Phillips Planning Services Ltd.
Town Planning and Development Consultants

2019/0323/P Flats 1, 2 & 3 3 Akenside Road London NW3 5BS

Conversion of 2 x 3-bed flats to form 1 x 4-bed maisonette at ground and first floor levels; erection of single storey rear extension with roof terrace enclosed by balustrades above; installation of 2 x new side windows at ground and first floor levels and 1 x new side door to form separate access to Flat 3; erection of new front bin store.

Existing balcony / terrace at No.3

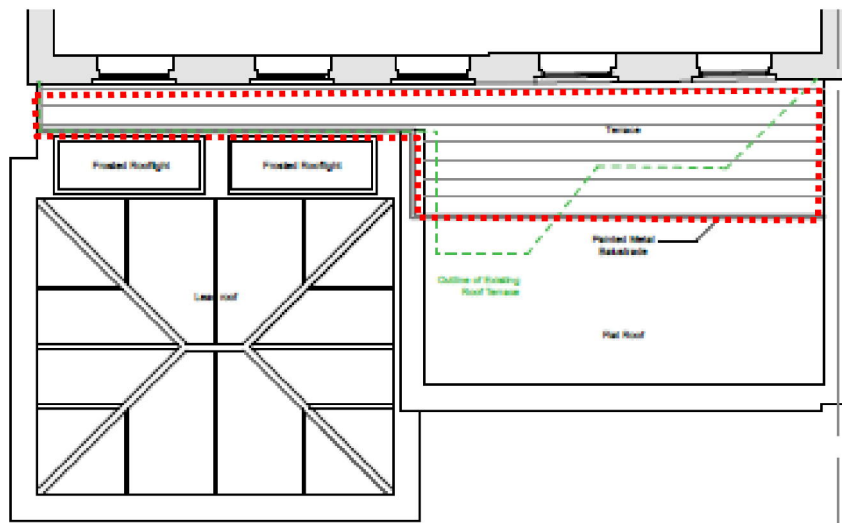
To place our clients concerns in context it is helpful to summarise the existing and permitted position at the site. Firstly, the application property is divided into three flats. The first-floor flat benefits from a small balcony area at first floor level. This is set away from the boundary with our client's property as shown below.

Terrace as approved in 2016 (2015/1207/P)

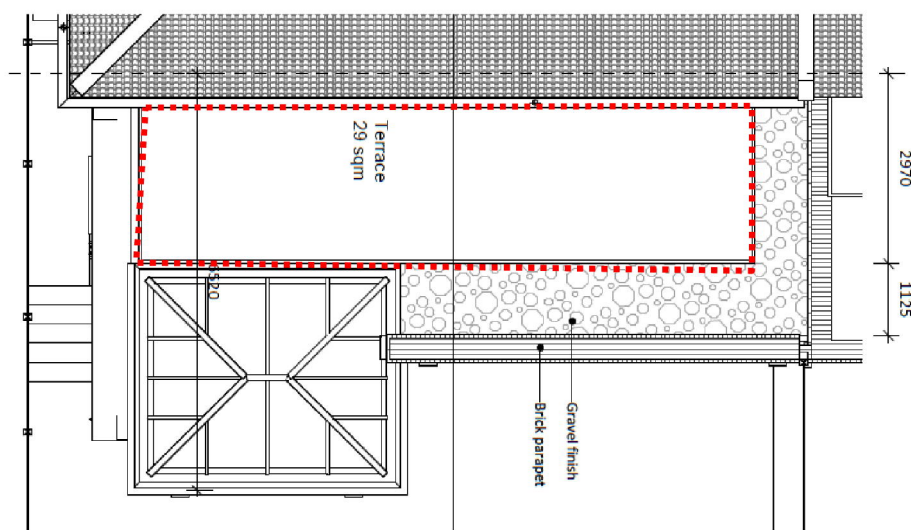
In 2016 permission was granted alongside works at No.2 for an extension at the ground floor rear and alterations to the terrace as shown below. Whilst the external amenity space for the flat was moved closer to the shared boundary its depth was relatively modest.

Had they been aware of this 2017 proposal objection would have been raised at that time as significant concern exists over its scale and position relative to the shared boundary, the rear windows of No.2 and the skylights of the ground floor extension.

Terrace as approved in 2017 (2017/4653/P)

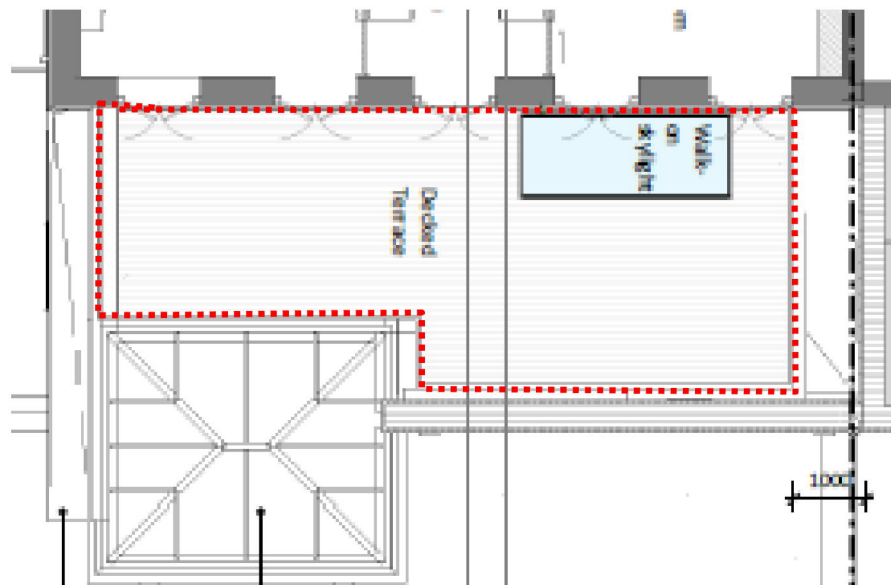
As shown the terrace as approved in 2017 was shown set in from the boundary with our client's property and also set back from the full extent of the projection of the ground floor extension.

It is our clients submission that if a terrace is to be again permitted at first floor level it should not be of any greater scale nor should it be any closer to the shared boundary than that which was approved in 2017.
